State of Idaho
Department of Water Resources
Permit to Appropriate Water

NO. 63-32103

RE: Permit No. 63-32103

Comment Report

Figure 1: TDS and tritium concentrations versus well depth in deep, regional aquifer wells (Hutchings and Petrich, 2002a).

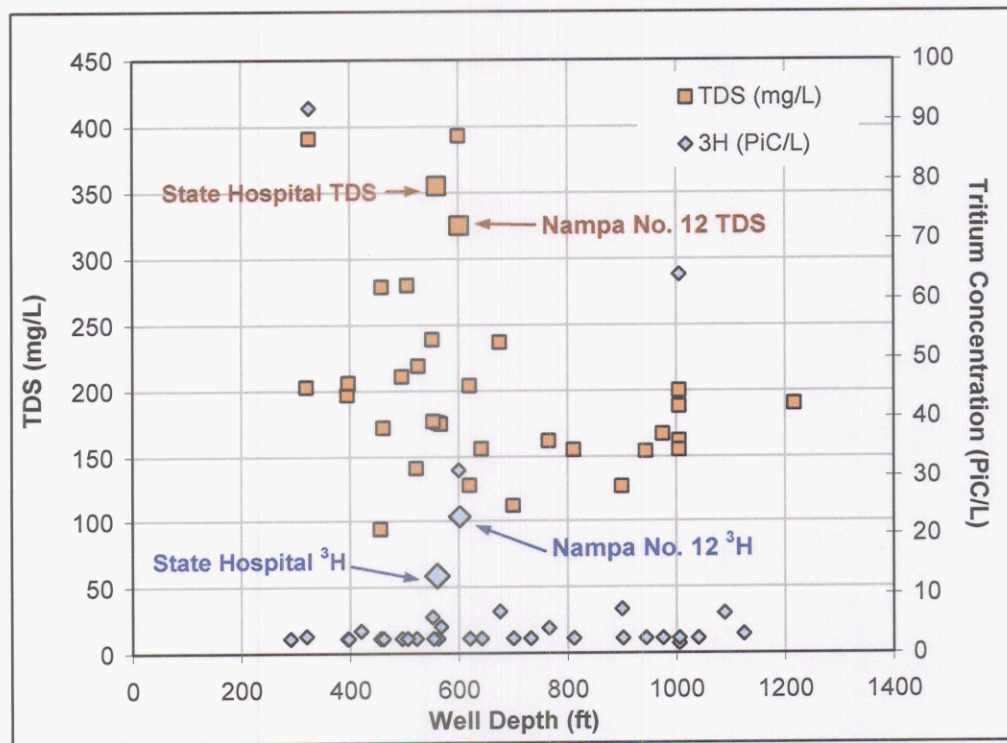
The primary IDWR concern regarding the proposed Sorrento mitigation plan is that the Sorrento well draws water from intermediate-depth aquifers and that mitigation at ground surface or in shallow aquifers does not mitigate aquifers from which the Sorrento well draws water. This would especially be of concern if the Sorrento well were drawing water from the deep, regional Treasure Valley aquifer system (regional aquifer characteristics are described below). However, ground water chemistry data (primarily TDS data) from the Sorrento well indicate characteristics associated with shallow ground water. These data indicate that the Sorrento well draws water from aquifers that are recharged from shallow zones, not from the deep, confined, regional Treasure Valley ground water flow system.

TDS and tritium concentrations in wells penetrating the deep, regional Treasure Valley ground water flow system (Hutchings and Petrich, 2002a) are shown in Figure 1. Most of the wells completed in the deep, regional system had TDS concentrations less than 250 mg/L and tritium concentrations less than 10 pCi/L. Elevated TDS and tritium concentrations would indicate that at least some of the water has (1) encountered shallow valley sediments and (2) entered the ground water flow system during the last four to five decades.

Figure 2: Map showing locations of wells in the vicinity of the Sorrento site.

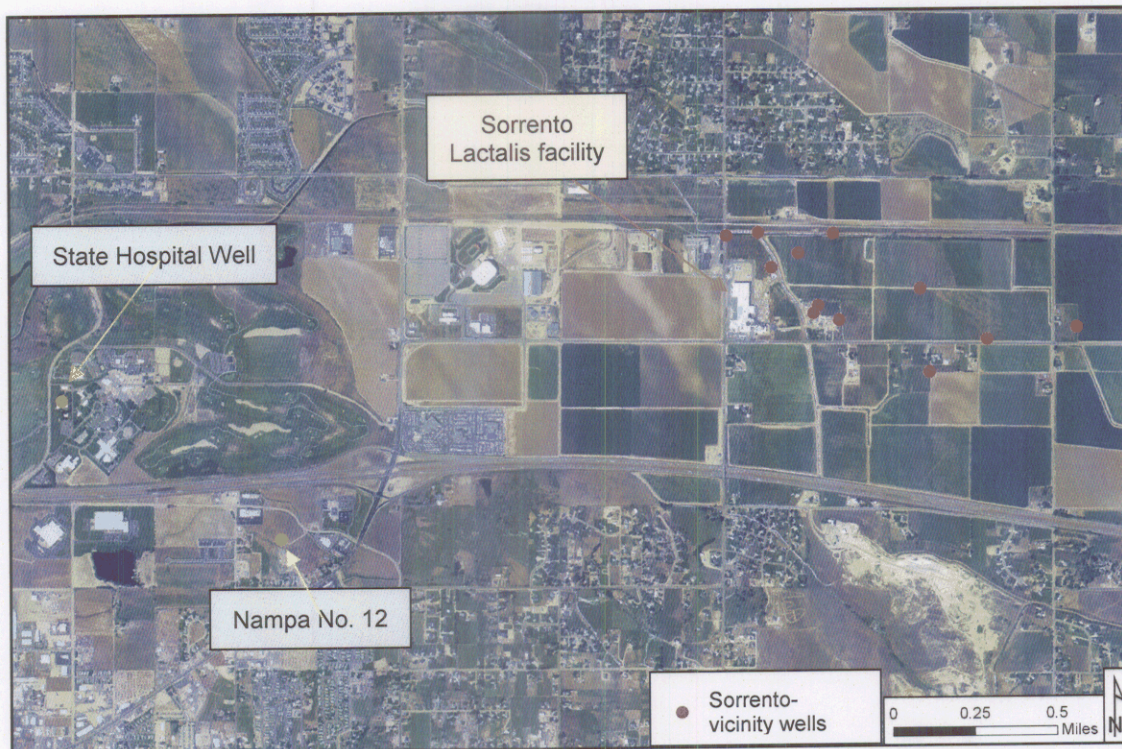
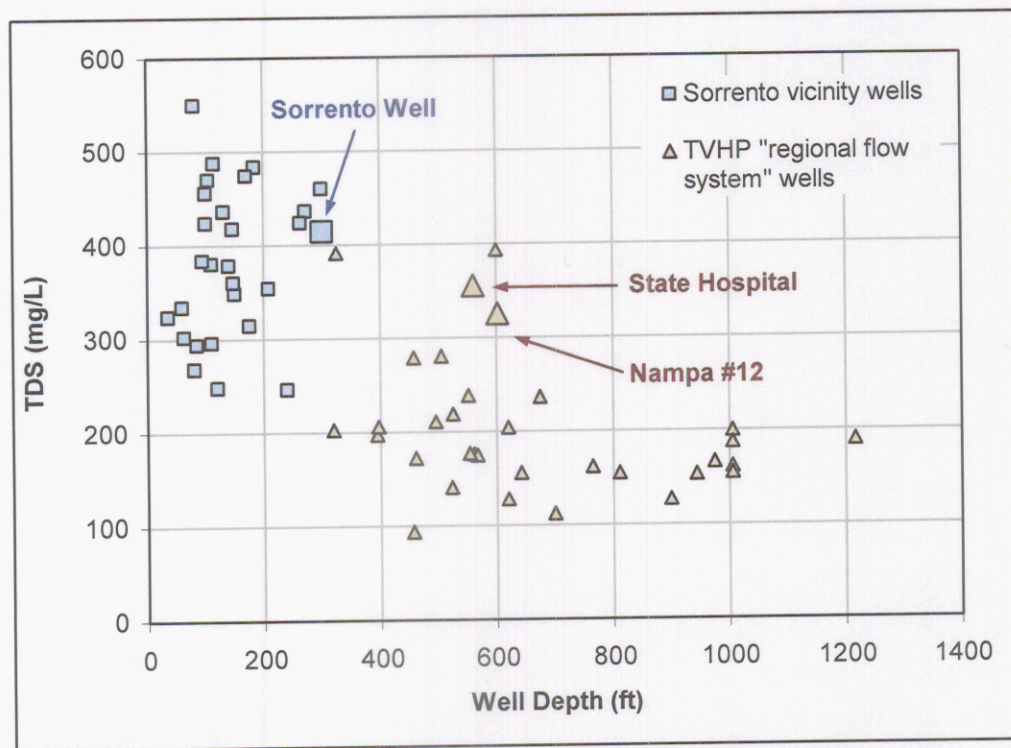
Ground water samples collected from wells within ¼ mile of the Sorrento facility (and including the Sorrento well) were analyzed as part of a well acceptability analysis (Scanlan Engineering, 1996). Most TDS concentrations were between 250 and 550 mg/L (Figure 3), indicating that at least some of the water in these wells had come into contact with shallow sediments. The TDS level in the Sorrento well (414 mg/L) was greater than in any of the TVHP study wells completed in the deep, regional

aquifer system, and was similar to TDS levels in the State Hospital and the Nampa No. 12 wells.
